**FAIRMONT STATE UNIVERSITY  
MARION COUNTY, WEST VIRGINIA**

**SQUIBB WILSON BLVD. PAVING**

**ADDENDUM #1**

**THRASHER PROJECT #030-10338**

SHEET No.  
**5**

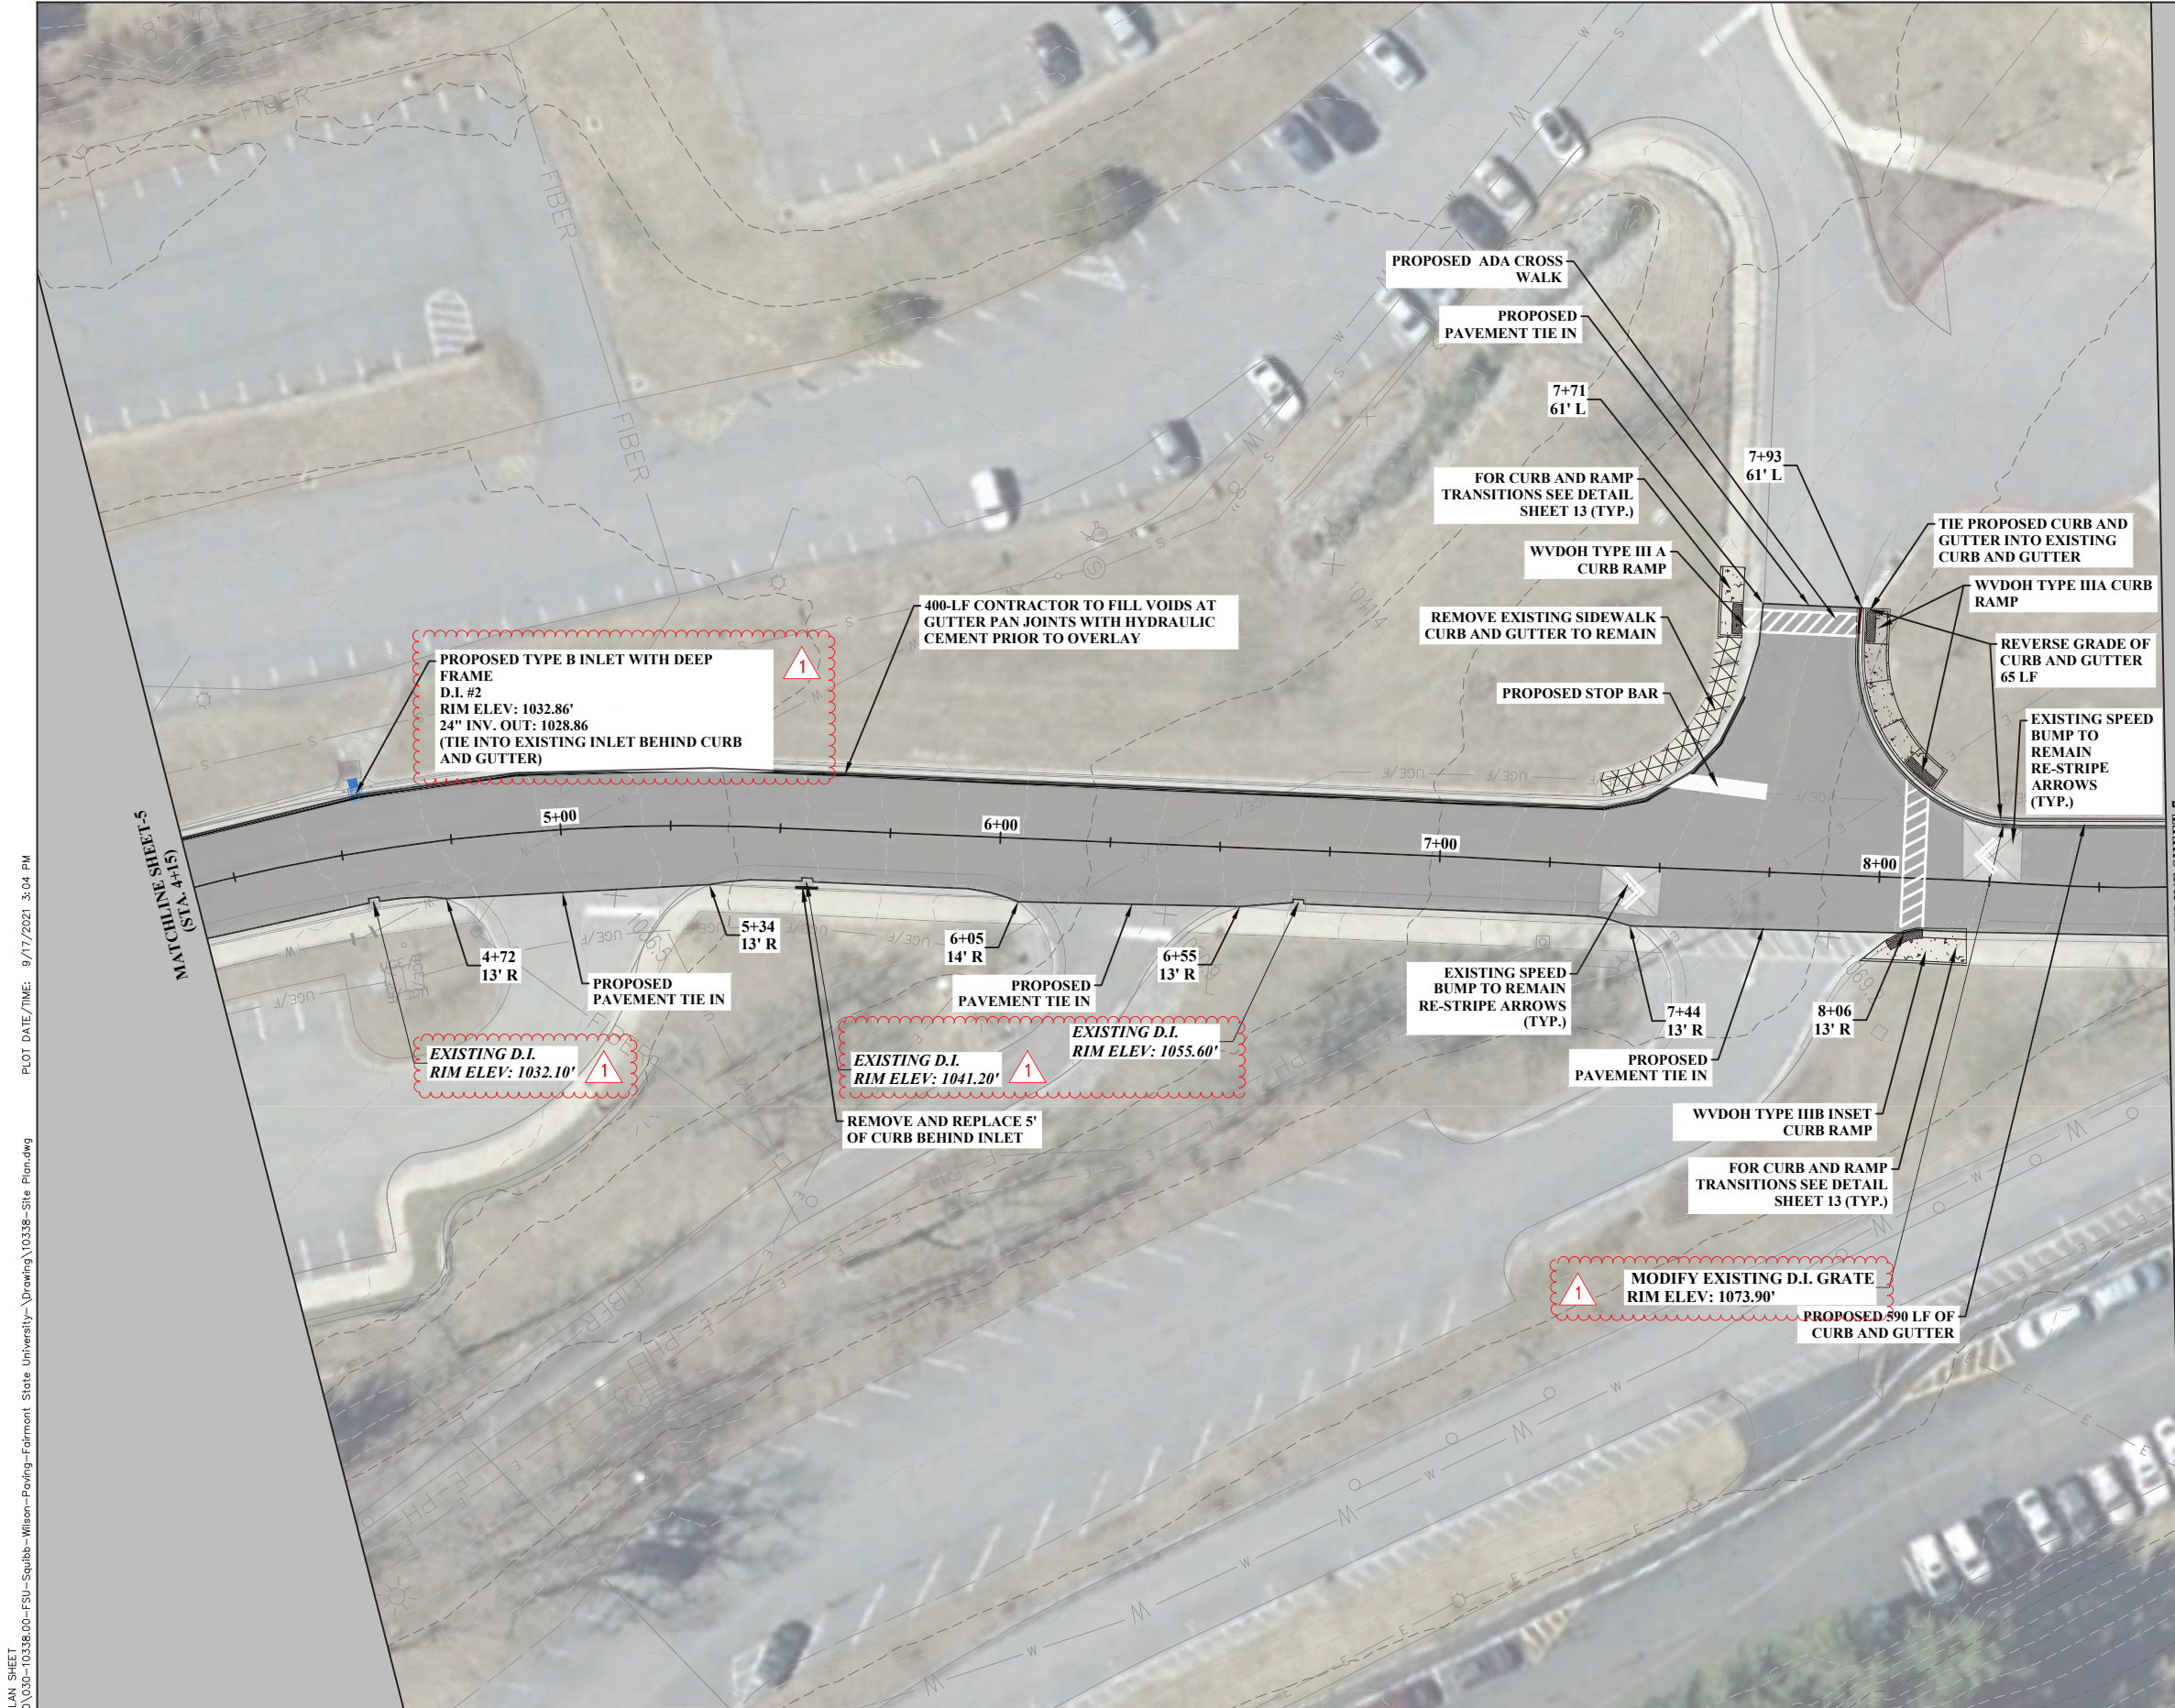
Plans Sheets 5, 6, & 7:

- Invert elevations were added to the proposed Drainage Inlets that are being replaced or added.

1. Would you be able to provide the invert elevations for the inlets on this project.?

Inverts have been provided on revised plan sheets 5, 6, & 7.

20-LF CONTRACTOR TO FILL VOIDS AT GUTTER PAN JOINTS WITH HYDRAULIC CEMENT PRIOR TO OVERLAY  
 REMOVE AND REPLACE EXISTING INLET WITH TYPE B INLET WITH DEEP FRAME  
 D.I. #1  
 RIM ELEV: 1028.30'  
 INV. OUT: 1025.30'

NO.	BY	DATE	DESCRIPTION
1	CRW	9/15/21	REVISED RIM ELEVATIONS AND ADDED INVERTS
